Town of Brunswick, Maine

DRAFT FINDINGS OF FACT REQUEST FOR CERTIFICATE OF APPROPRIATENESS FOR ADDITIONS AND ALTERATIONS VILLAGE REVIEW BOARD

PROJECT NAME: 37 School Street Barn

CASE NUMBER: VRB 25-012

37 School St.

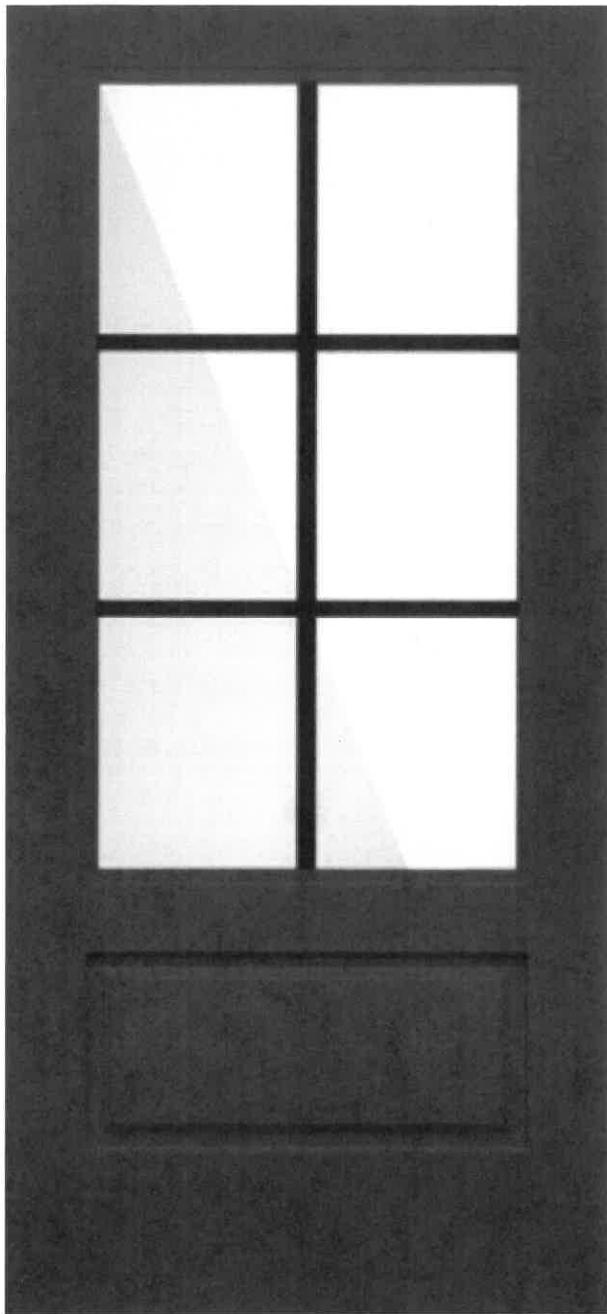
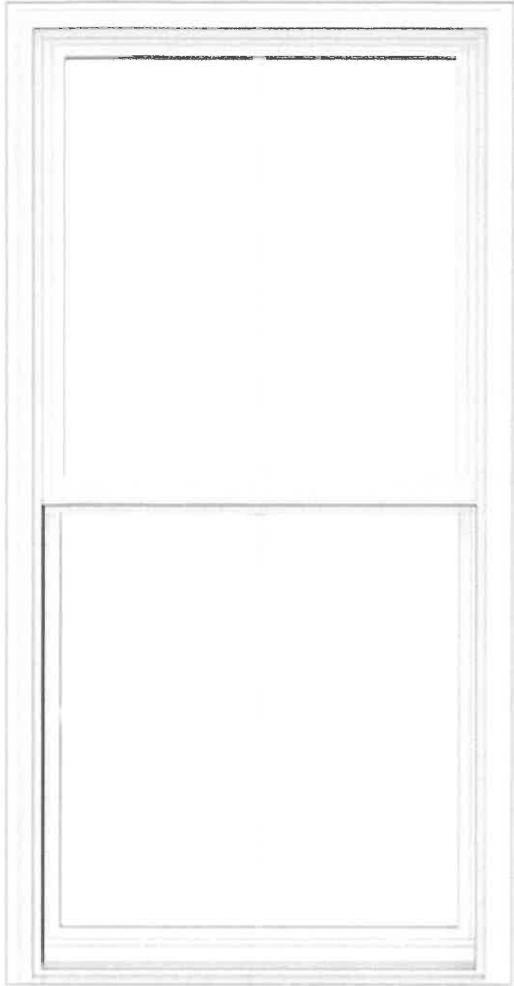
The proposed modifications to the property require a building permit in addition to a Certificate of Appropriateness due to the increase in size of one of the window openings.

Most of the modifications the applicant proposes will only be slightly visible, if at all, from School Street. The most visible change, the faux brick skirting, will mimic the home's brick foundation for a cohesive look and won't affect the structure's historic integrity. The solid skirting (as opposed to the existing lattice) has been requested by the applicants' homeowner's insurance. The applicants intend to bring a sample of this skirting to the Village Review Board meeting.
